CONWAY
HISTORIC DISTRICT COMMISSION
AUGUST

**CONWAY
HISTORIC DISTRICT COMMISSION
MEETING**

**ROBINSON HISTORIC DISTRICT
CERTIFICATE OF APPROPRIATENESS REVIEW
MORGAN REMODEL REVIEW
835 WATKINS STREET**

**OLD CONWAY DESIGN OVERLAY DISTRICT
CERTIFICATE OF APPROPRIATENESS REVIEW
BRUCE STREET APARTMENTS
1311, 1313, 1315, 1317 BRUCE STREET**

Proposed finishes & materials

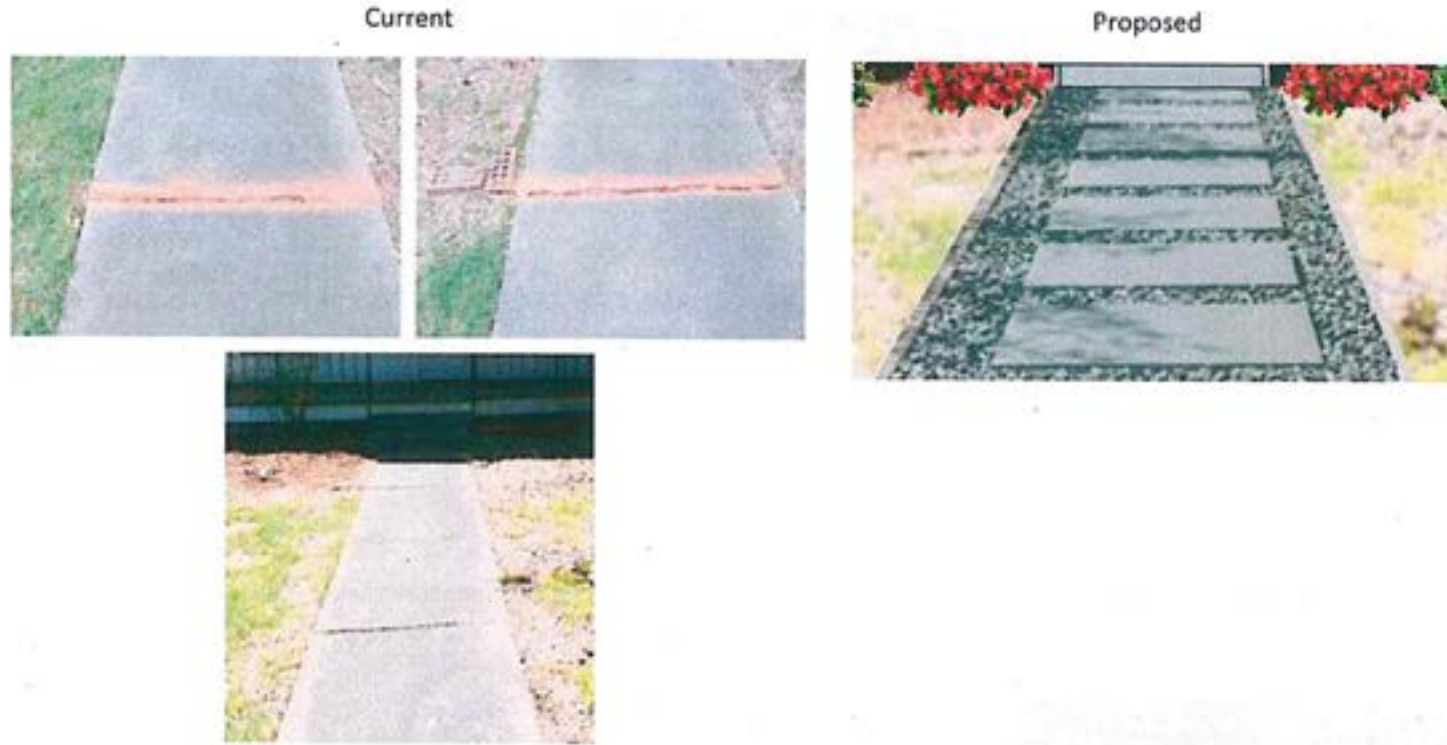
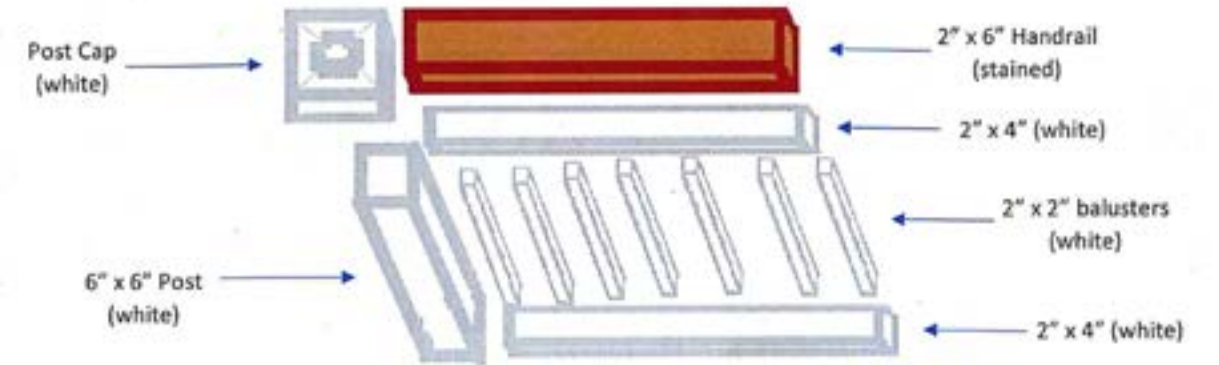
Architectural Details, Siding, and Bricks. Eaves, brackets, dentils, cornices, moulding, columns, trim, etc. The residence is sided with modern siding. The survey indicates that it is metal siding. The applicant intends to replace the bottom 3 rows of siding as it is water damaged. The existing front porch railing is ornamental iron. Likely the railing was added in the 1960s when ornamental iron was in vogue. More traditional wooden railing is proposed. The wall mounted mail box and house numbers are also planned to be replaced.

General comments. The planned improvements to the front porch and yard would seem to be in keeping with the structure and area structures. The railing would offer a return to a more traditional look for the residence and would accent the front porch more favorably than narrow ornamental iron. The removal of the silver maple would seem a good long term improvement. Silver maples have a limited life span and can become hazardous. The unkind trimming has also fouled the tree.

1. Porch railings shall be constructed as shown on submitted plans.
2. Lighting, mailbox, and house numbers shall be installed as shown on submitted plans.
3. The existing sidewalk may be removed and replaced with large concrete pavers and river rock as proposed.
4. The large silver maple may be removed.

Site Plane including Staff changes

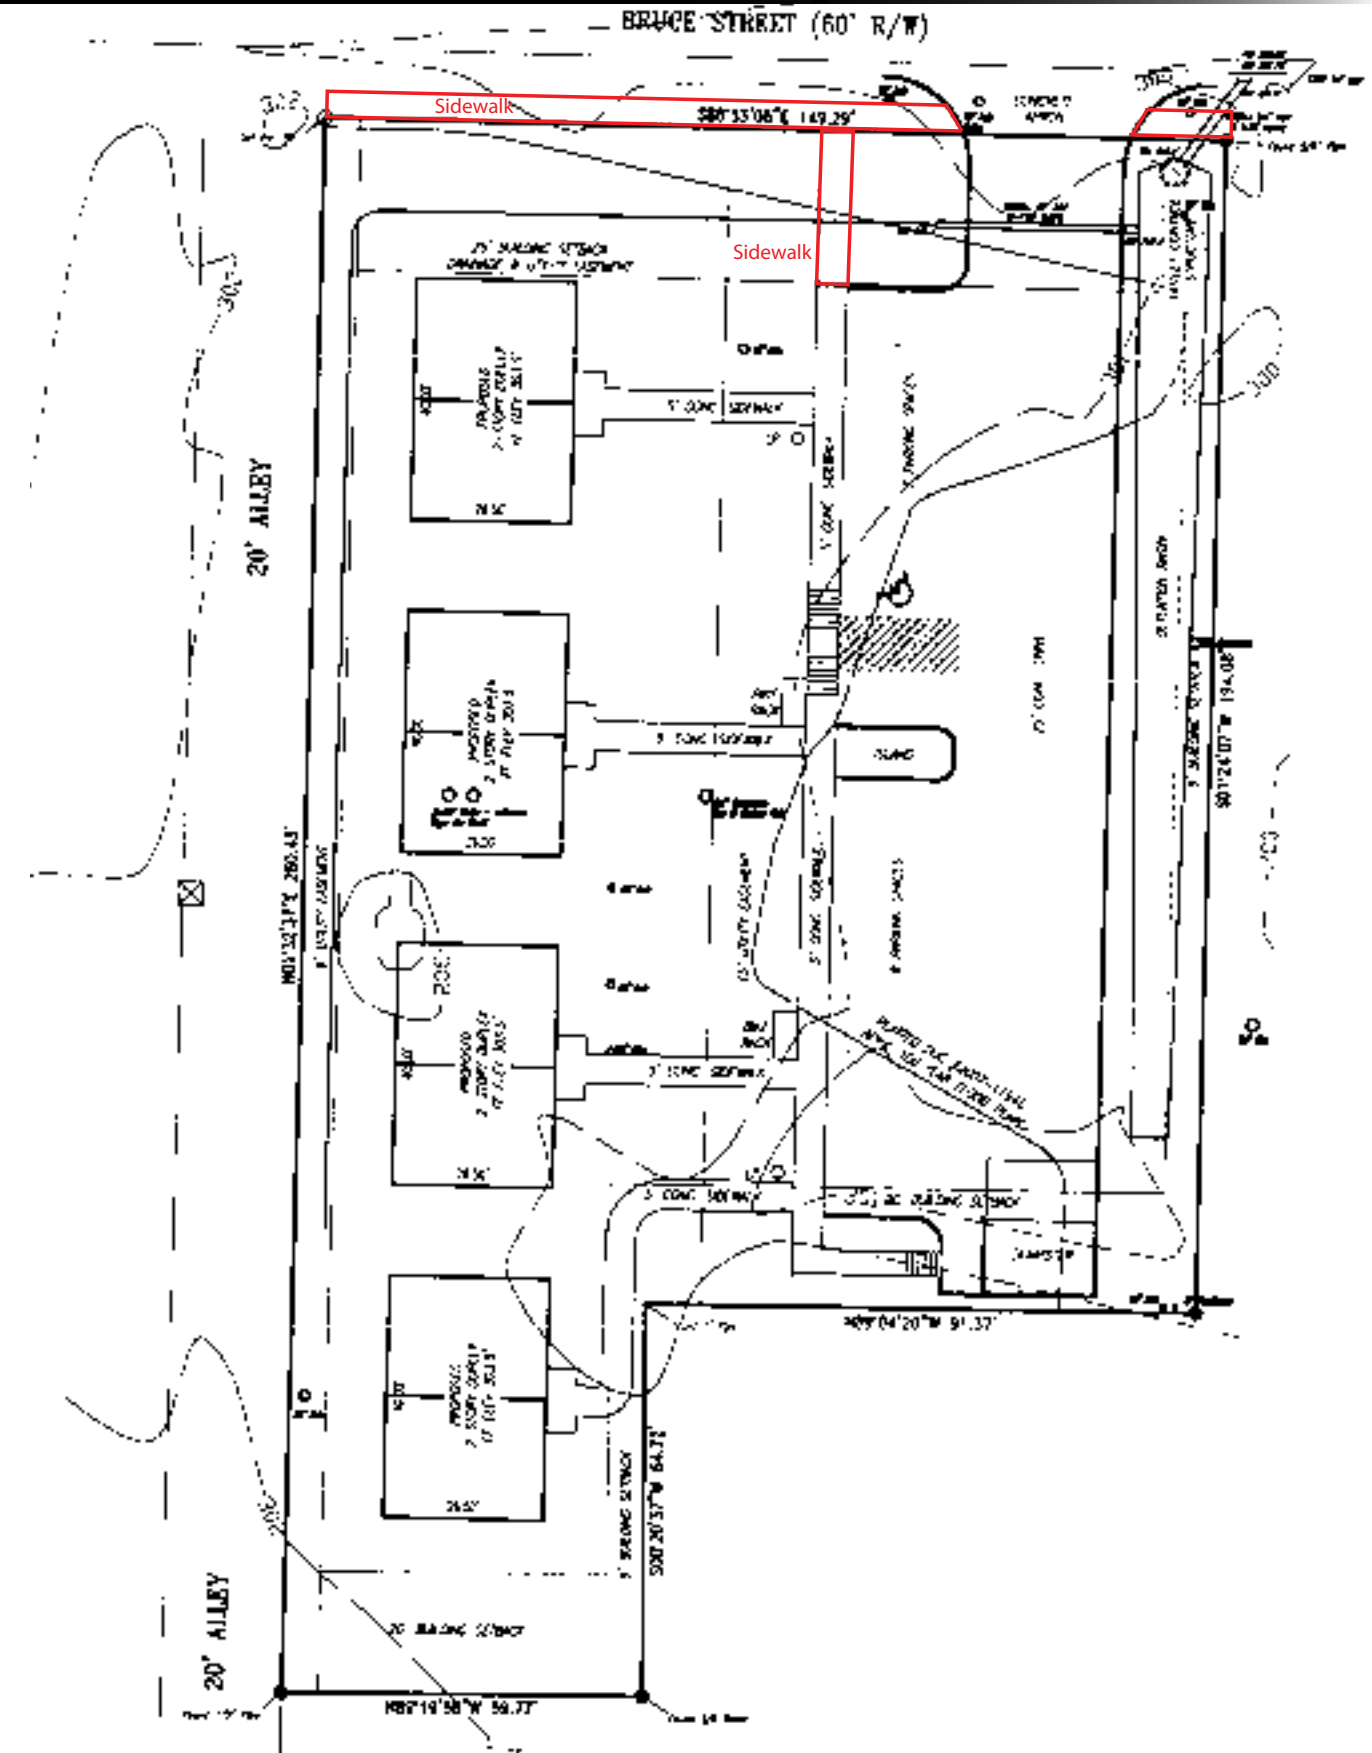
Driveway/Parking/Carport. A new driveway and parking area is planned on the east side of the property. The driveway appears to be 24 feet wide. The parking area will have 15 spaces. The city requires a minimum of 12 spaces. A dumpster is proposed at the south end of the parking area. The applicant could consider the use of roll carts instead.

Sidewalks. There are no sidewalks on the property along Bruce Street. Sidewalk construction or an in-lieu fee is required. There is around 125 feet of street frontage minus the driveway at \$12 per linear foot, requiring a sidewalk in-lieu fee of \$1500. An internal sidewalk links the duplexes to the parking area. If a sidewalk is constructed along Bruce Street, a connecting sidewalk from the internal sidewalk to Bruce should be constructed.

Tree preservation. No significant trees will be removed on the interior of the lot. A fence row with several significant trees exists along the east, south, and partially west property lines. These trees are likely straddling the requested property and abutting properties. Effort should be made to retain these trees as screening. A detention basin is shown along the east property line. Excavating could affect the survival of the existing fence row trees. Planning Department development review requires one tree per 30 feet along the perimeter. A deeper review could occur during development review to insure that mitigating perimeter trees are planted or fence row trees remain

1. The duplexes and driveway shall be constructed as shown in submitted plans.
2. Fence row trees shall be preserved as much as possible. Trees and landscaping shall be reviewed in depth as part of Planning Staff development review.
3. Four additional windows shall be placed on the left and right elevations as shown in Staff sketch.
4. Siding material?
5. HVAC and utility equipment shall be appropriately located at the rear or side of the structure and/or appropriately screened.
6. A 5 foot sidewalk shall be constructed along Bruce Street with an interior sidewalk connection to the new Bruce Street sidewalk.

Floor Plan & Elevations including Staff changes

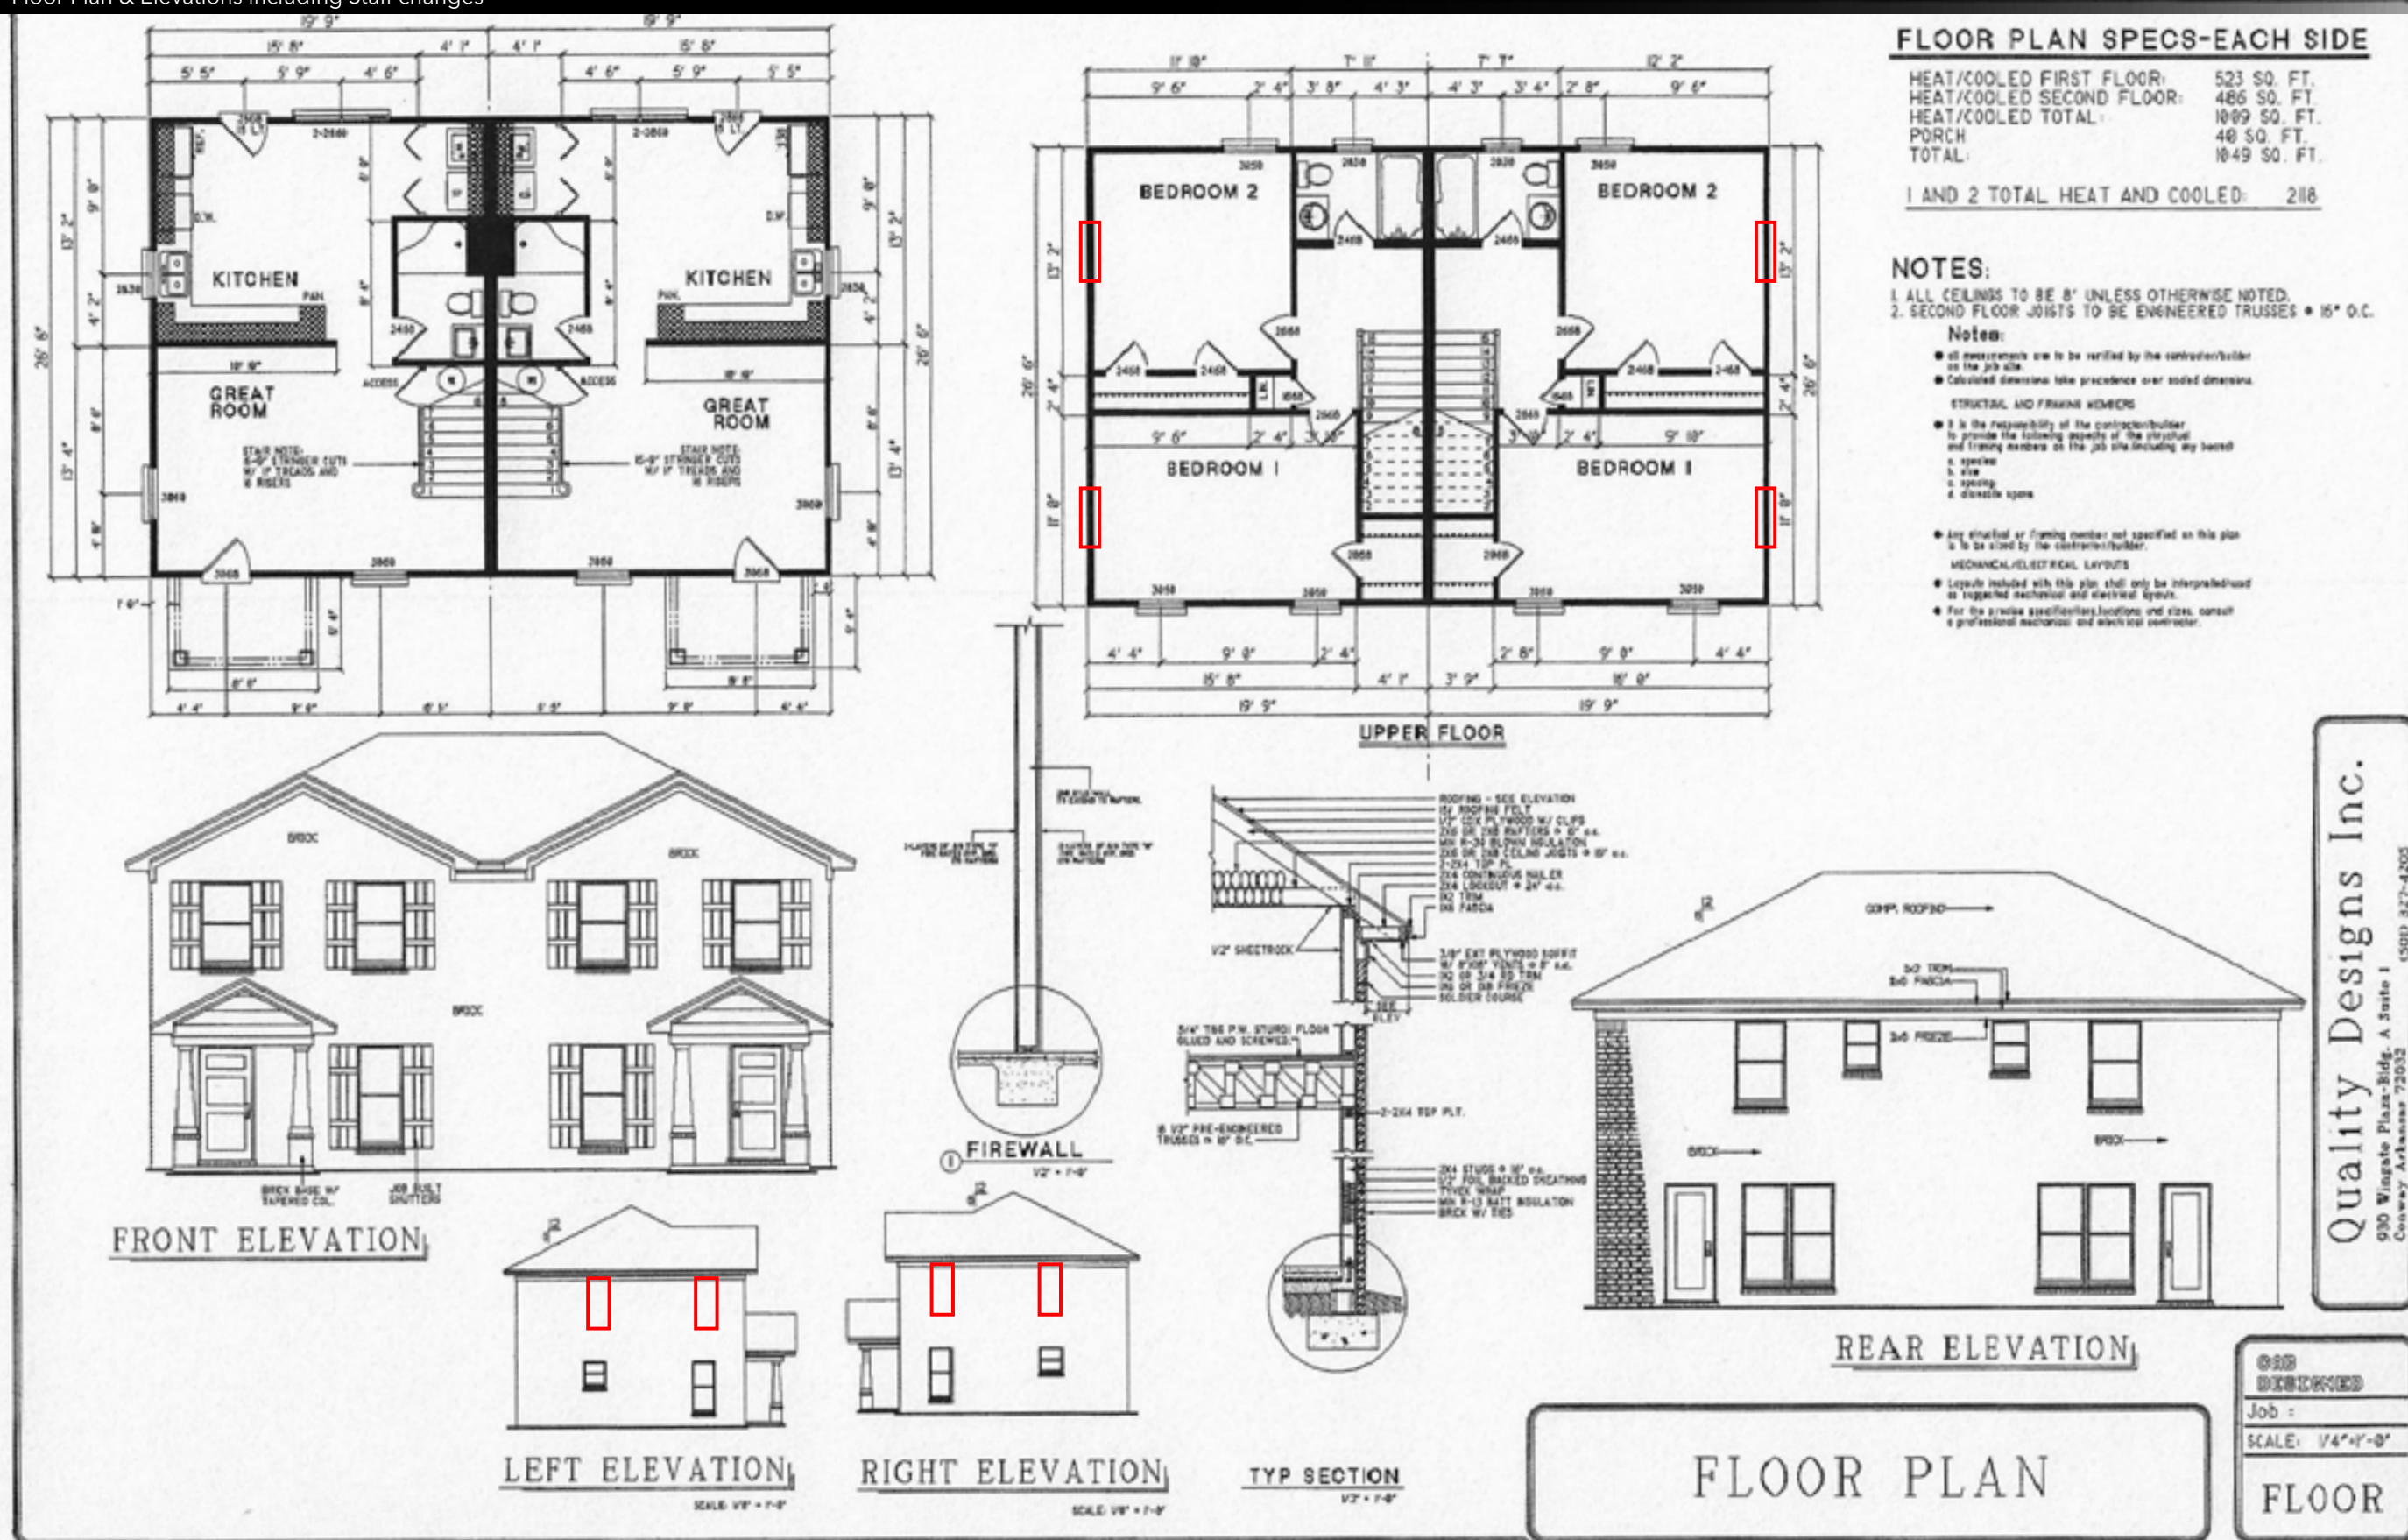
Facade, wall area, rhythm. Facades shall be compatible with surrounding historic structures in proportion of wall to opening area. The duplexes appear to have an appropriate number of windows and doors with the exception of the second story left and right elevations. 4 additional windows should be added to the bedrooms to create a more balanced end elevation.

Entries, Porches, and Porticos. Appropriate entry points are provided. Porches are to be a minimum of 6 feet in depth. The front entry is more of a portico rather than a true porch. They are shown at 5 feet 4 inches feet in depth. As a portico, this would be an appropriate depth. Porch columns have a tapered design and appear to be appropriately scaled to the overall design.

Architectural Details, Siding, and Bricks. Eaves, brackets, dentils, cornices, molding, columns, trim, etc. The duplexes are shown with brick on all 4 sides. A brick soldier course is shown under the fascia trim. A shiplap siding is shown in the portico gables. It is assumed that vinyl will be used for fascia trim and gable siding. The applicant can provide details at the meeting.
